Office Action Summary

09/749,677

Non-Final Rejection

2. Claims 1-4 are rejected under 35 U.S.C. 103(a) as being unpatentable over Miike (US 6,111,827) in view of Ohtsuka et al (US 5,297,127).

FIG.4

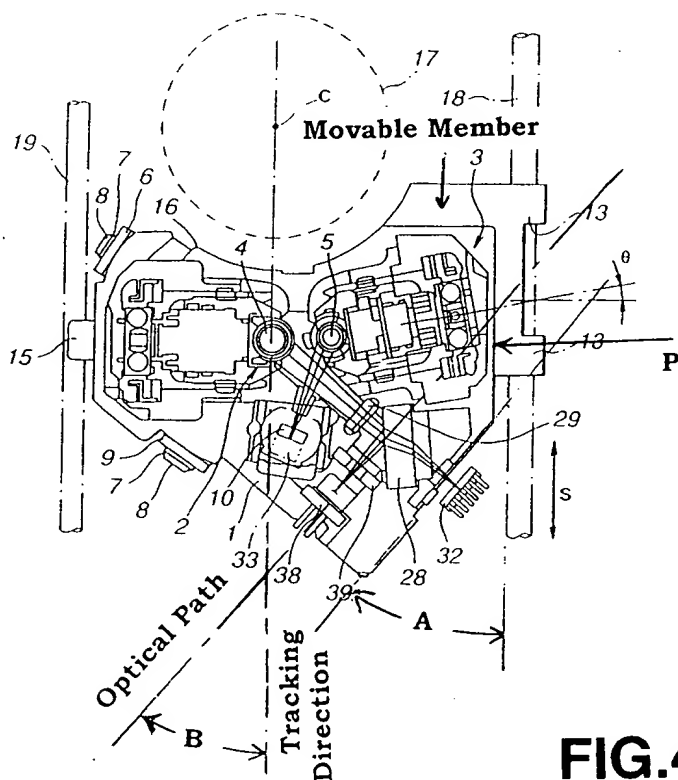
With regard to claim 1, Miike shows a mounting structure of a hybrid optical module in Fig.4 (a copy with added marks is attached in next page) including: a movable member (as marked) that is supported by two shafts 18 and 19, a recording medium drive apparatus shown in Fig 4 including a hybrid optical module 1 having a light emitting 38 (Fig. 4; column 13, line 14) and receiving device 32 (Fig. 4; column 14, line 31) mounted on the movable member, the hybrid optical module 1 being slid on the shafts 18 and 19 so as to perform a tracking operation on an optical recording medium (moving radially, column 6, lines 4-6), wherein a portion P of the hybrid optical module which is closer to one of the shafts 18 when the hybrid optical module is mounted on the movable member is cut out in substantially parallel with the shaft, and by an angle A which is substantially equal to an incident angle B of an optical path with respect to a tracking direction of the optical recording medium.

With regard to claim 2, Miike further shows that a spindle motor 17 (Fig. 4, column 6, line 12) is placed to be closer to the shaft 19 in a direction of light incidence of an optical system including the hybrid optical module, and the hybrid optical module having a cut portion P which is closer to another shaft 18 is mounted with a pick-up unit shown in Fig. 7.

With regard to claim 3, Miike further shows that the angle A by which the portion of the hybrid optical module is cut out is in a range of 30° to 45° substantially.
